গণপ্রজাতন্ত্রী বাংলাদেশ সরকার
শ্রম ও কর্মসংস্থান মন্ত্রণালয়
কলকারখানা ও প্রতিষ্ঠান পরিদর্শন অধিদপ্তর

ক্যাপ পর্যবেক্ষণের তথ্য

কারখানার নাম	এয়াপারেল ইন্ডাস্ট্রি লিঃ		
ঠিকানা	House # 82 (3Rd Floor), New Air Port Road, Banani, Dhaka		
কারখানার কোড	DHK057		
কালার কোড			
মূল্যায়নের ধরন: বৈদ্যুতিক মূল্যায়ন		পর্যবেক্ষণের তারিখ: ০৫-০৪-২০২৩	
১. পর্যবেক্ষণ

৬.১. কার্যক্রম

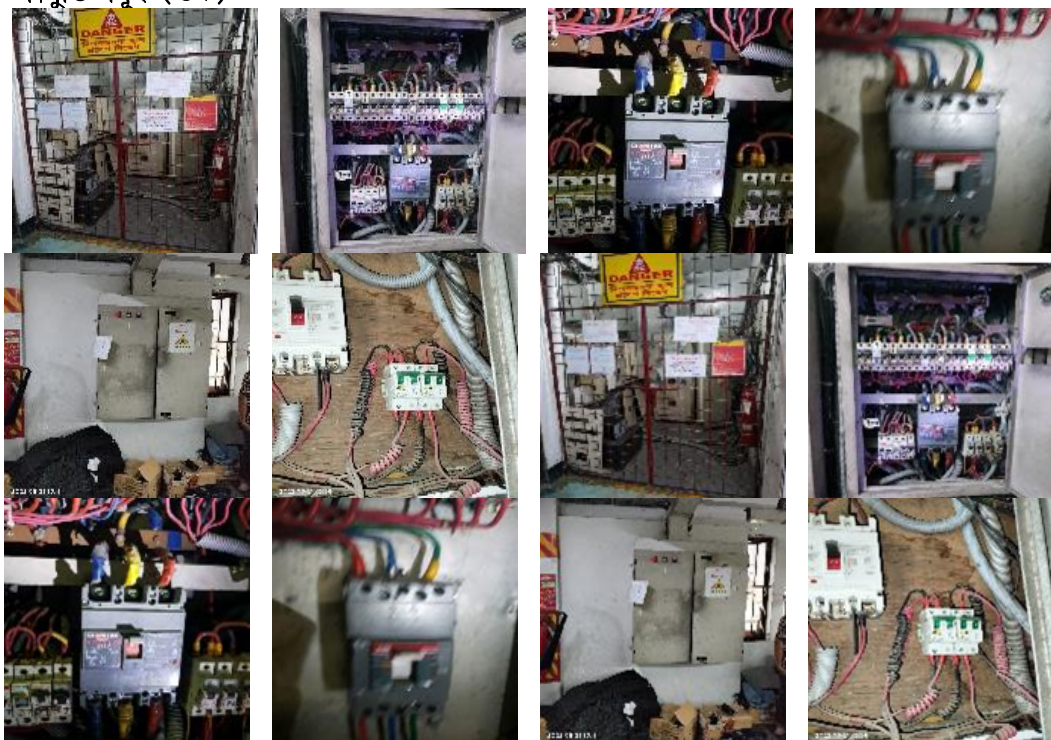
পরিদর্শন পর্যবেক্ষণ	☐ Ventilation of substation is poor ☐ No SLD/clear identification mark on distribution panel ☐ No instruction for first aid to electrical shock and artificial respiration ☐ No indicating lamps on the panel ☐ Temporary connection from the substation ☐ Loose cabling/connection without lug/and no cable trench ☐ Non-conductive mat not provided/ insufficient ☐ No detector in substation
ক্যাপ আইটেম ক্যাটাগরি

কার্যক্রম	☐ Ensure ventilation to substation ☐ Provide instructions for first aid and artificial respiration from exposure to electrical shock. ☐ Provide cover on the cable trench and sufficient rubber mat in front of the panel ☐ Ensure all connections with lugs and proper cable dressing
সুপারিশের তথ্যসূত্র	
কারখানার কার্যক্রম	We will provide require requirements as per suggestion.
অগ্রাধিকার	প্রযোজ্য নয়
চূড়ান্ত সময়সীমা	০৫-১২-২০১৭
সংশোধিত সময়সীমা	০১-০১-১৯৭০
অগ্রগতির অবস্থা	শুরু হয়নি
মন্তব্য	06-07-2020, 02-11-2020 : No SLD/clear identification mark on distribution panel .No instruction for first aid to electrical shock and artificial respiration. Non-conductive mat not provided/ insufficient. No detector in substation. 02-06-2021, 11-08-2021 : 1.Inadequate ventilation of substation room. 2.No clear identification markings of panel boards. 3.Instruction board for first aid and artificial respiration is not located in substation room. 4.Meters and other electrical devices (Ammeter, Voltmeter, PFI Auto Controller, etc.) installed on the main electrical equipment are not operational. 5.Panel body earthling continuity conductor (ECC) have no adequate size and door earthling were not present in some panel boards. 6.Some cables does not have proper lugs when terminated in the breaker or bus bar. 7.No appropriate detectors installed for Substation room. 21-08-2022 : 1. Ventilation of substation is poor 2. No SLD/clear identification mark on distribution panel 3. No instruction for first aid to electrical shock and artificial respiration 4. No indicating lamps on the panel 5. Temporary connection from the substation 6. Loose cabling/connection without lug/and no cable trench 7. Non-conductive mat not provided/insufficient 8. No detector in substation. 05-04-2023: Same as before.
